# Access Compliance Report

## Public Rights-of-Way

### (Pedestrian Signals)

Intersection ID: N/A	Main Street:	Cross Street: N/A	Location: N/A
ADA ID: 0140EF5BD5C4	Signal Type: One Push Button-Non APS	Overall Compliance: No	Severity Score: BTN 1: N/A BTN 2: N/A No BTN: N/A
Codes/Mitigation Info/Possible Solution		Field Measurements/Component Compliance

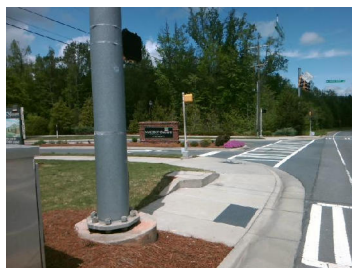
PROW/ADA: R404.2, R404.3, R406.2

Possible Solutions: Remove and Replace Clear Space.

Total Cost: \$ 400.00
